Item No. 3 Palliser Major Redevelopment Site Area Master Plan (North Kildonan Ward) File SP 2/2013

Title: Palliser Major Redevelopment Site Area Master Plan, SP 02/2013

Department: Planning, Property and Development
Division: Urban Planning
Prepared by: J. Glen Doney, Senior Planner
Date: July 9, 2013
File: SP 02/2013

45) **on Figure 14, which is the Land Use and Transportation Policy Map**

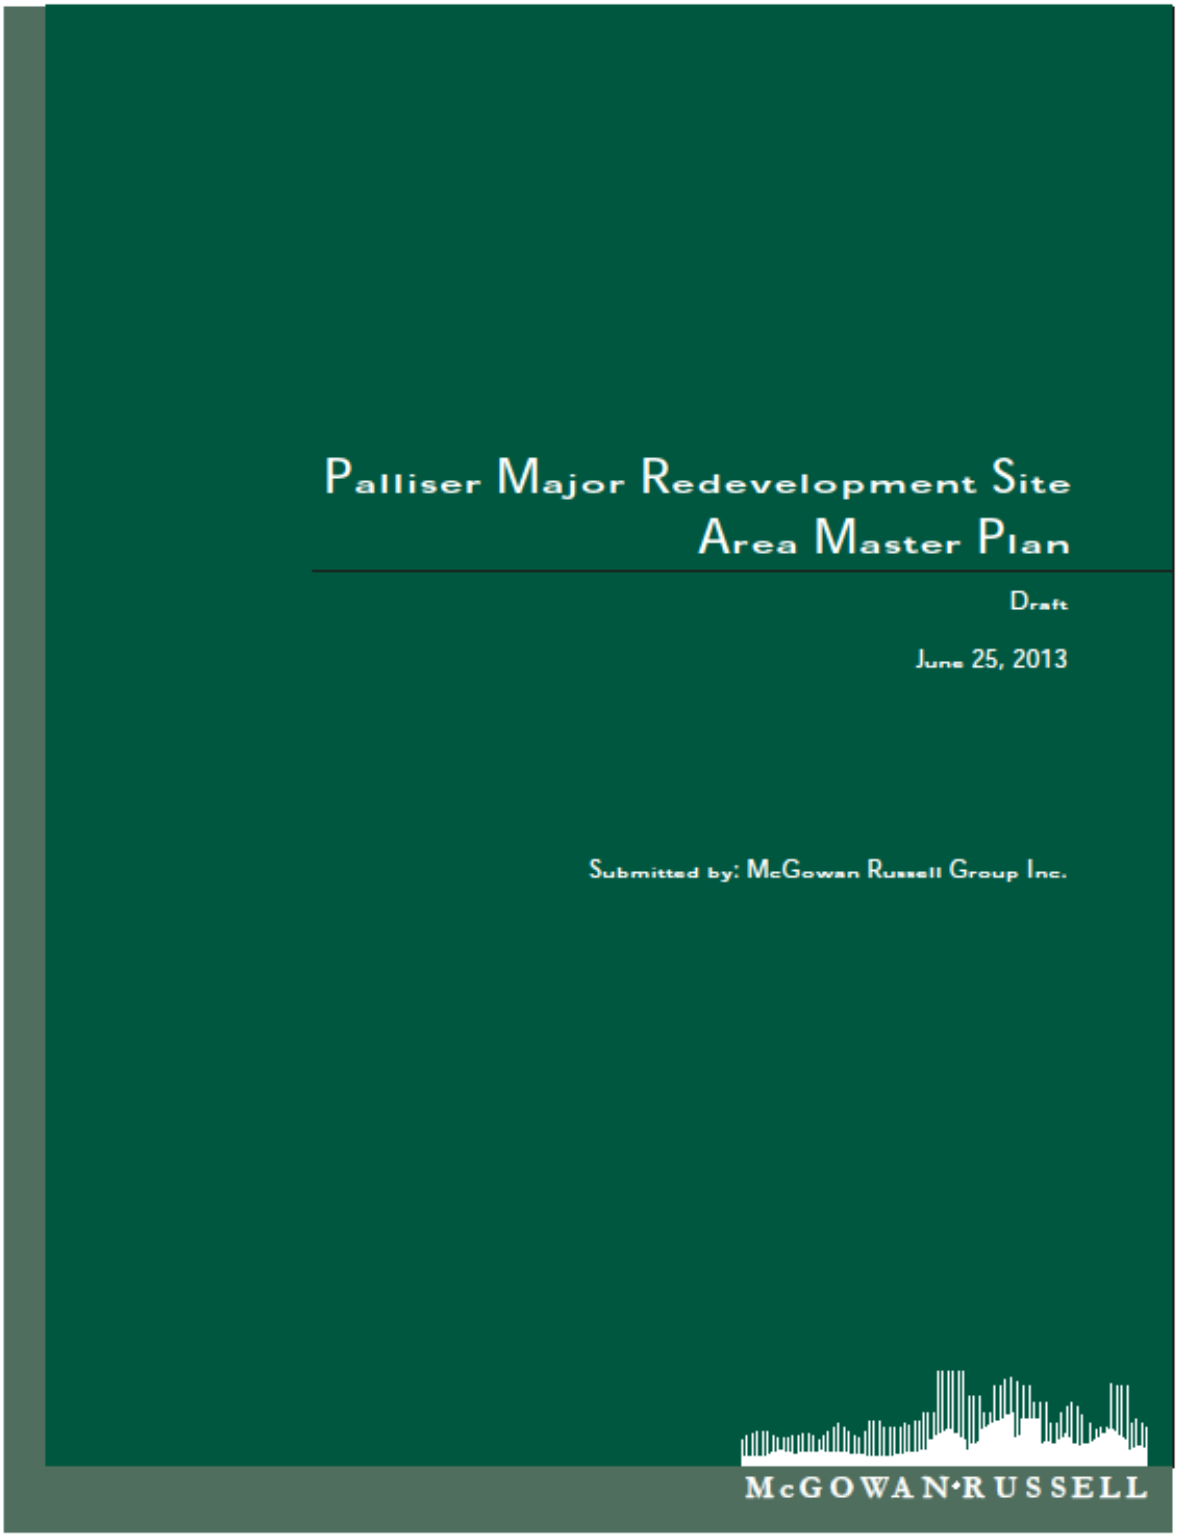
- **extend the green area indicating a landscaped buffer alongside Springfield Road west to Gateway Road,**
- **delete the view corridor on the map and in the legend,**
- add "see section" after the hyphens in the legend and add an "*" after the section references in the legend,
- below the legend, insert "* See also Sections C1, C2, C3, C7, C8 and C9." and
- after "landscaped buffer" in the legend insert " – see Subsection C3.2.4".

The recommended amendment in the first bullet, above, is ensure the Plan is consistent in establishing a buffer between development in the Palliser Major Redevelopment Site and the residential neighbourhood to the north.

The recommended bullet in the second bullet, above, is to remove an inconsistency in the plan, which is that the view corridor would not allow for the creation of a high-density, pedestrian-oriented environment along parts of Lexington Park and Gateway Road.
